ARCHITECT'S SUPPLEMENTAL INSTRUCTIONS

Project:	Lumberyard District – Buildings 2, 6, 8 & 9 Omaha, NE	Initiated By		Distributed To	
Project Number:	15927	<input type="checkbox"/>	Owner	<input checked="" type="checkbox"/>	
Owner:	Lanoha Development	<input type="checkbox"/>	Architect	<input checked="" type="checkbox"/>	
To Contractor:	Overland Constructors 5036 South 135 th Street Omaha, NE 68145	<input type="checkbox"/>	Contractor	<input checked="" type="checkbox"/>	
		<input checked="" type="checkbox"/>	Consultant	<input checked="" type="checkbox"/>	
		<input type="checkbox"/>	Field	<input type="checkbox"/>	
		<input type="checkbox"/>	Other	<input type="checkbox"/>	
Supplemental Instruction No.:	004				
Date:	July 8, 2016				
Contract Date:	February 15, 2016				
Contract For:	New Construction				
By:	Holland Basham Architects

Description: Revise data locations and deck light fixtures in the units.

SHEET: **E6.02**

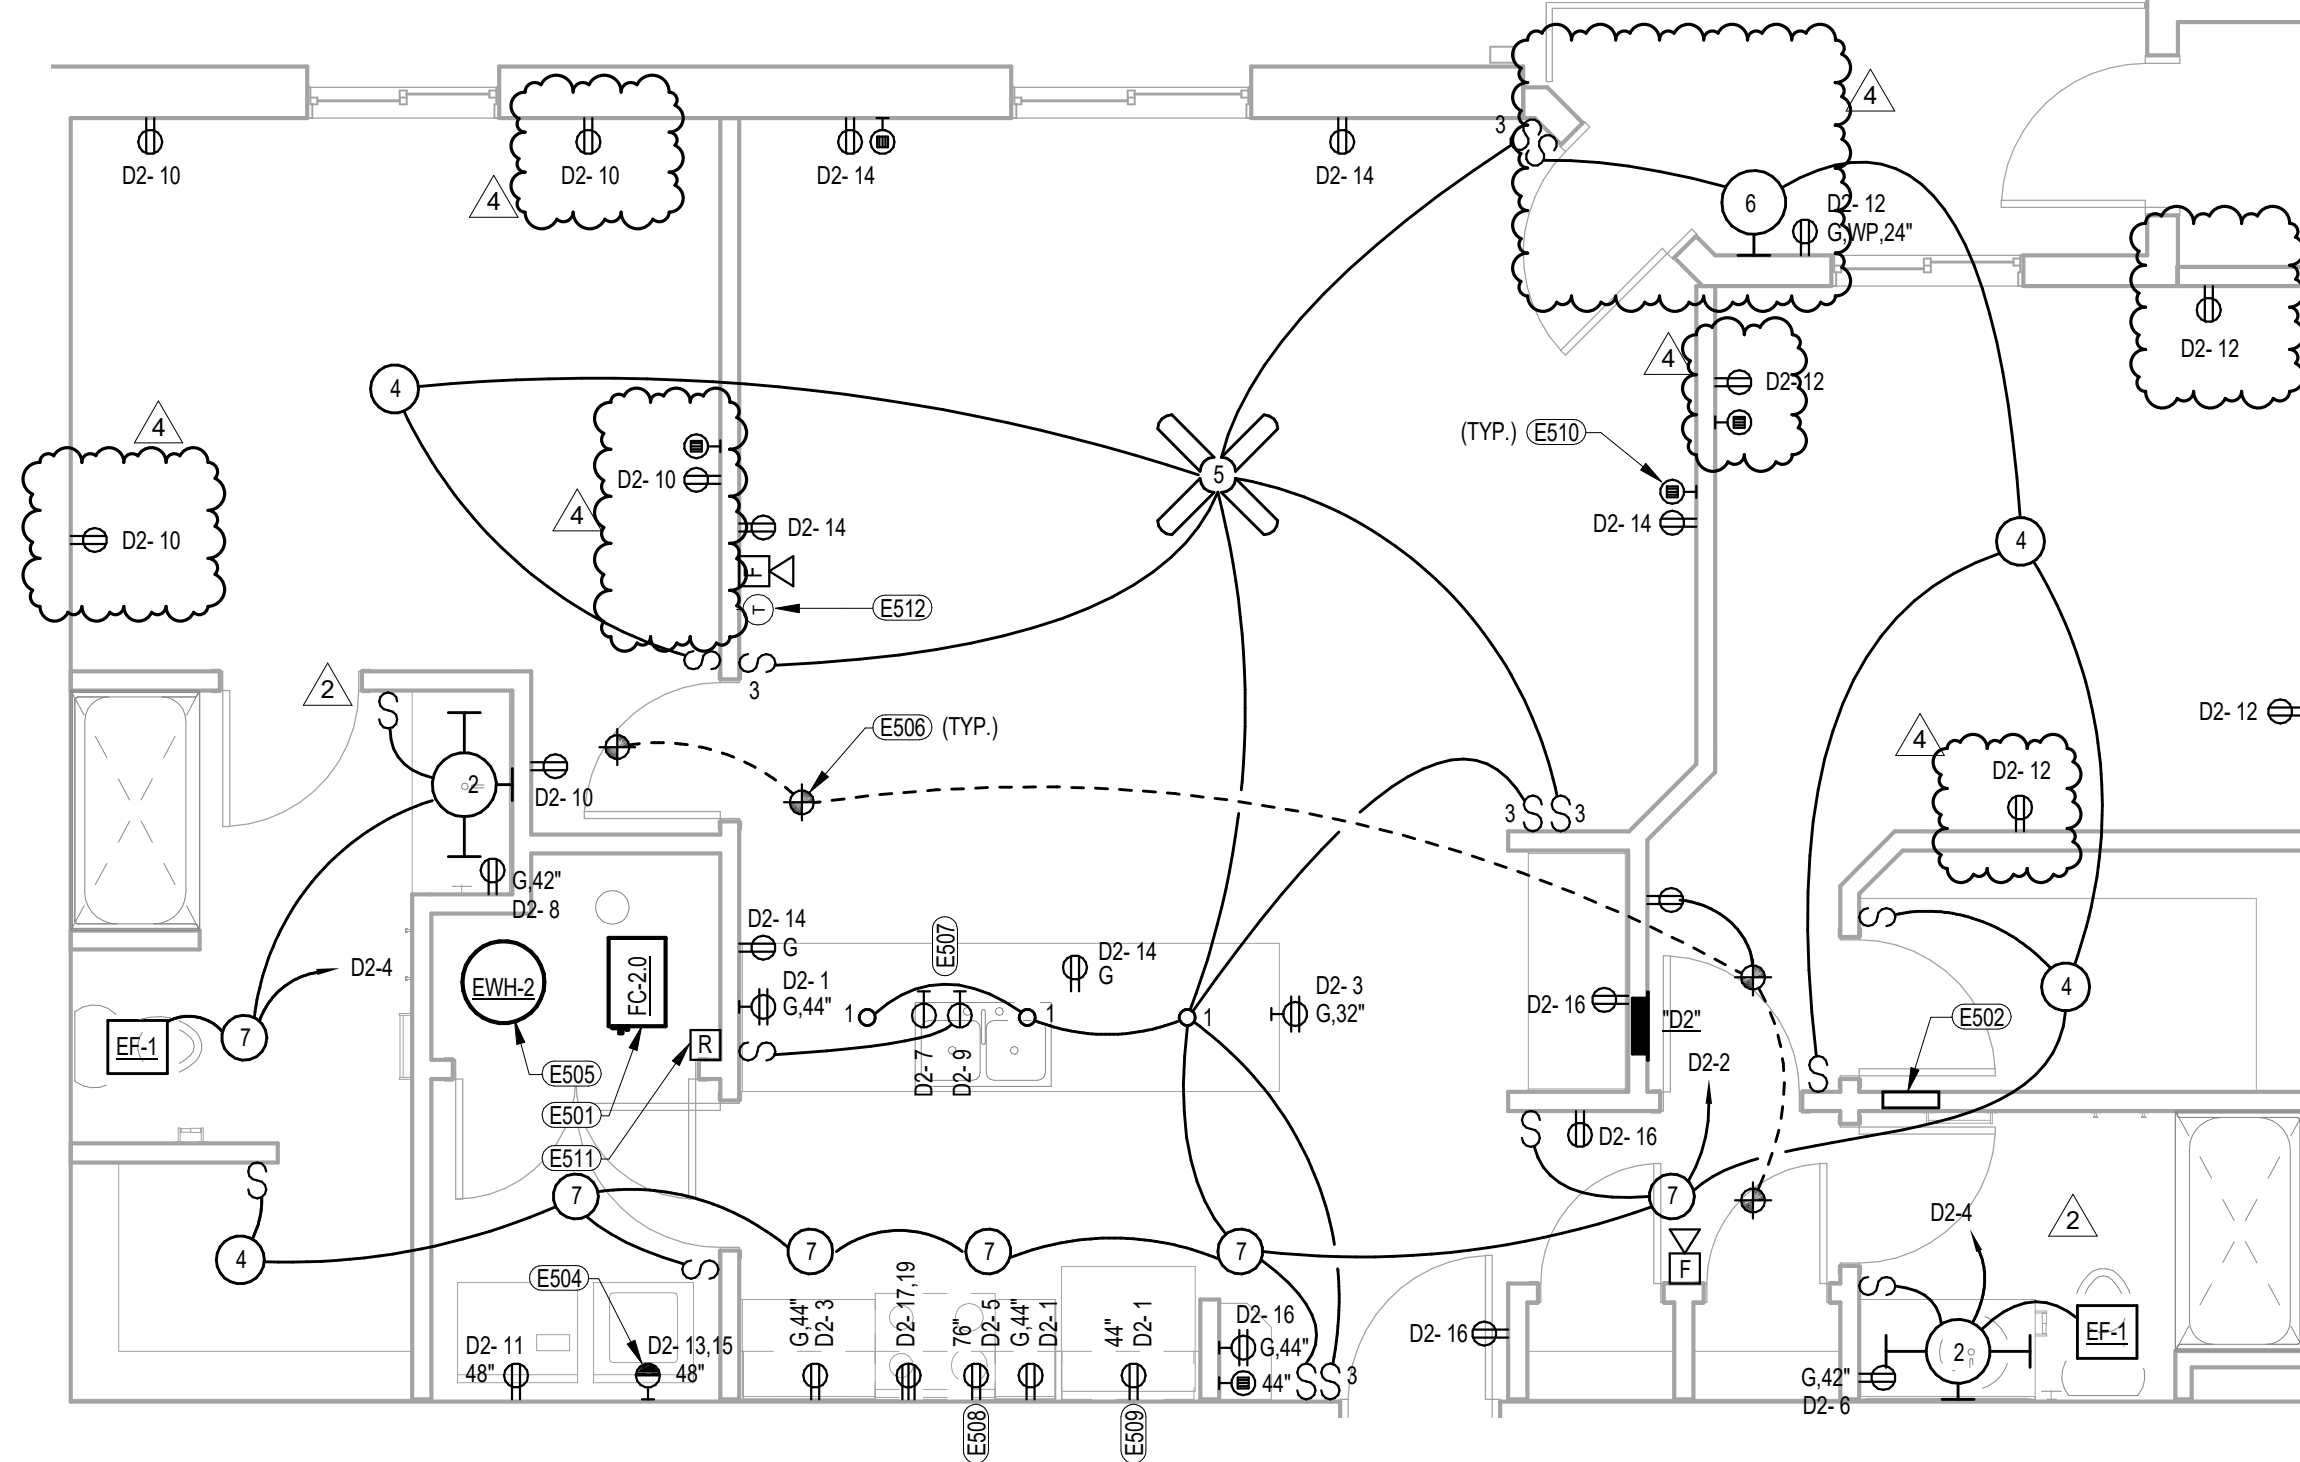
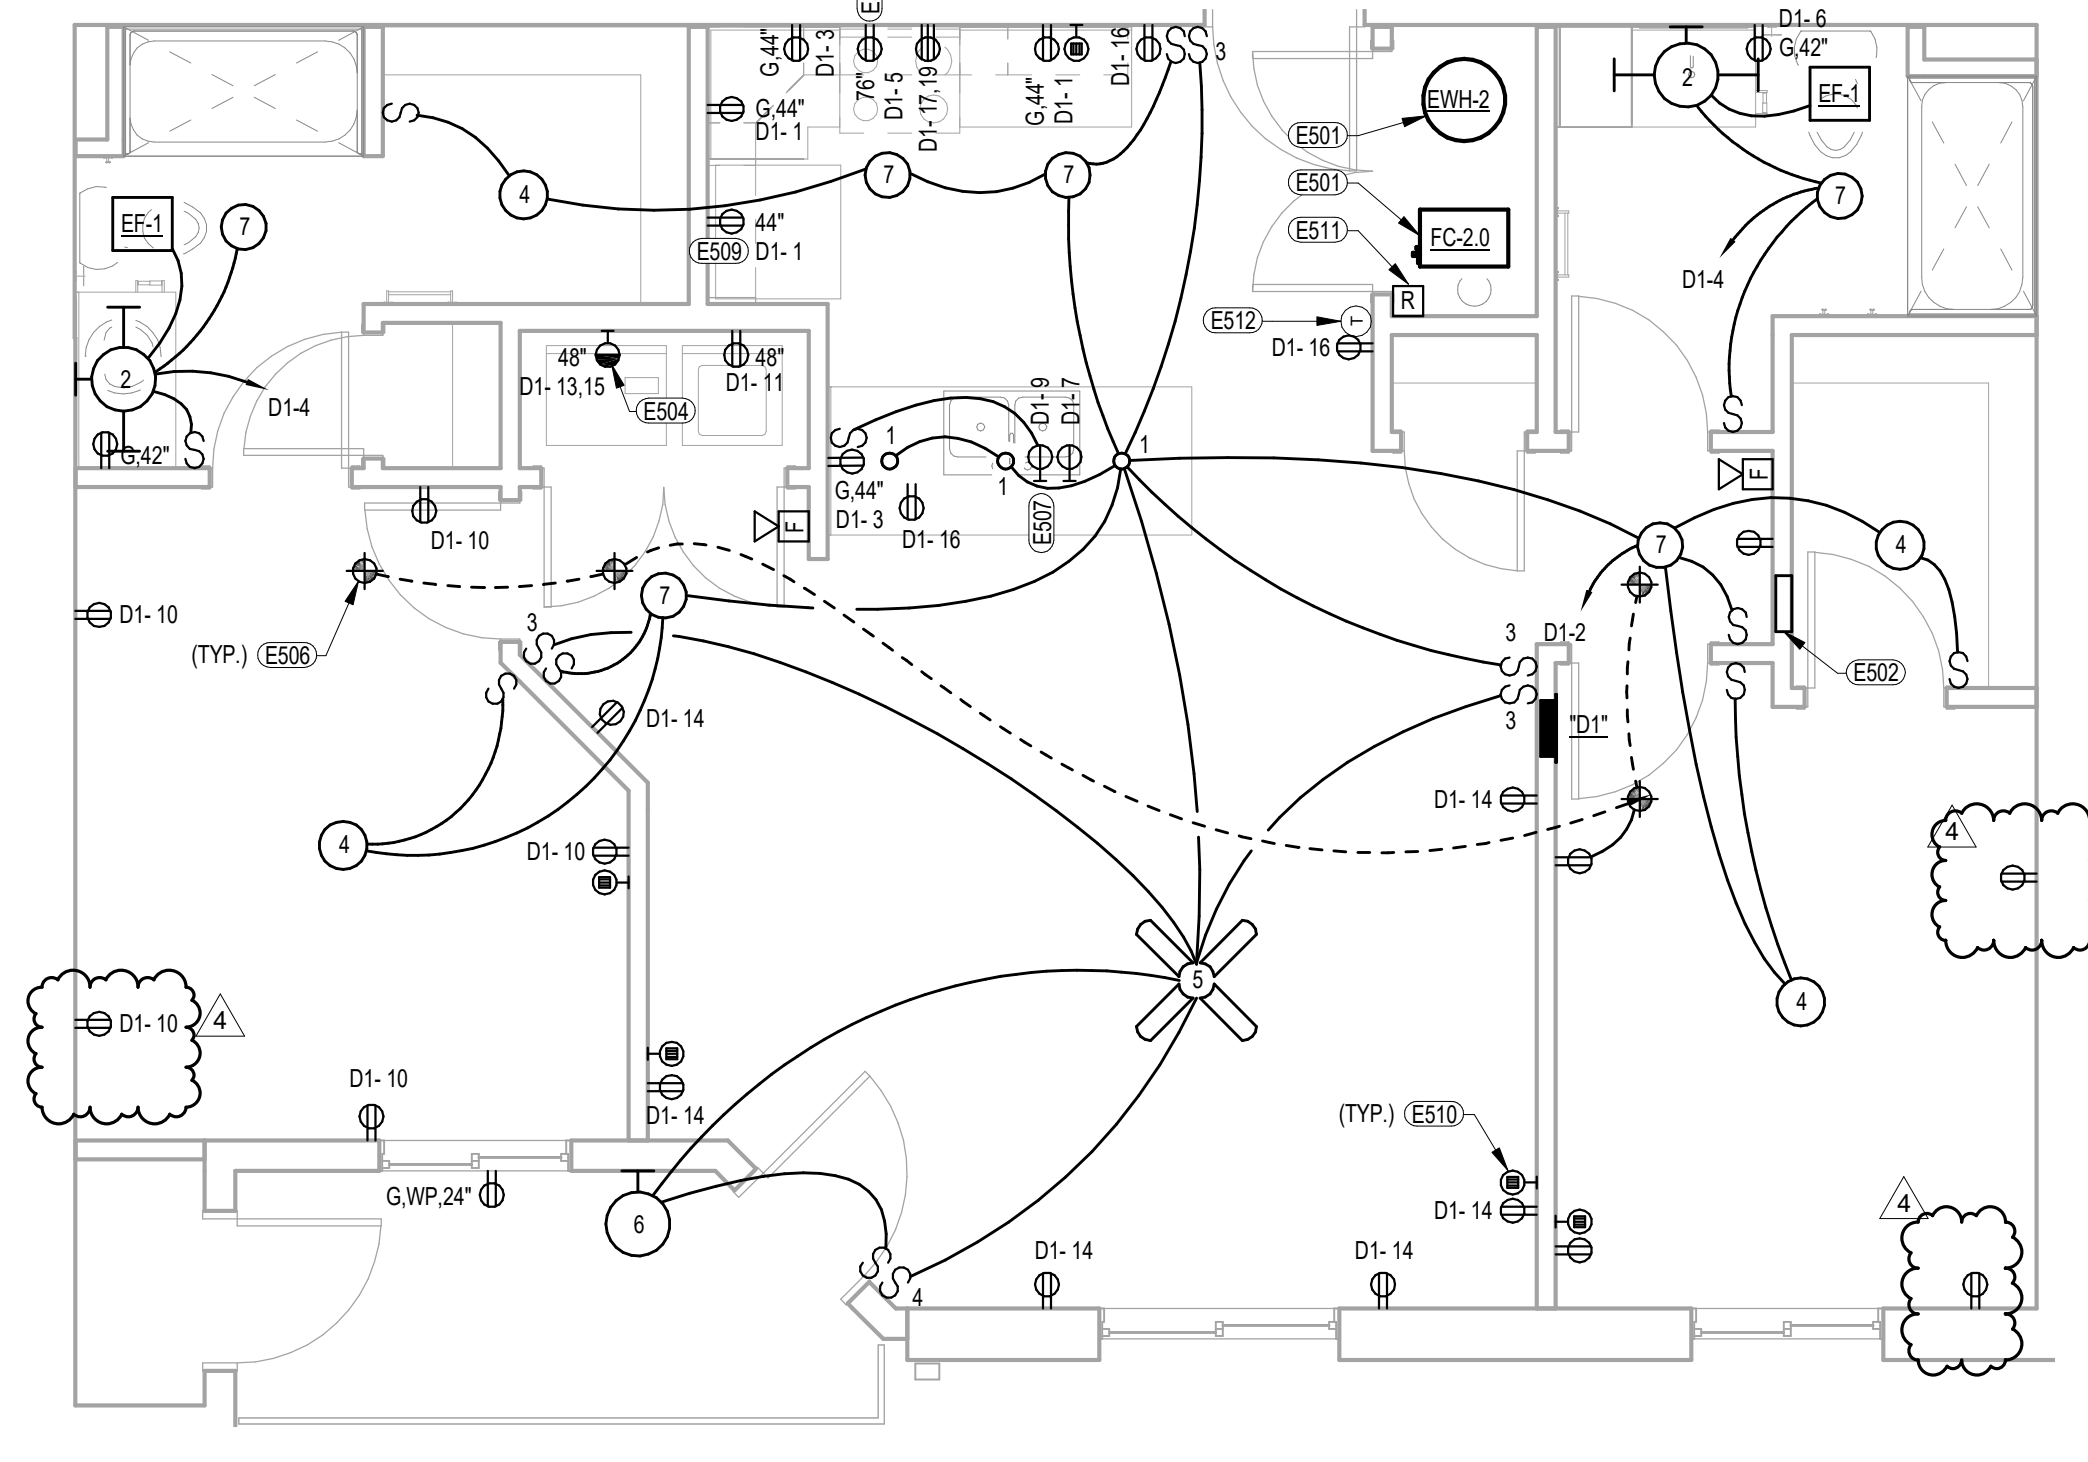
2. Sheet E6.02 – Enlarged Unit Plans - Electrical
 - a. Revise unit plans as shown in the attached Sheet E6.02.
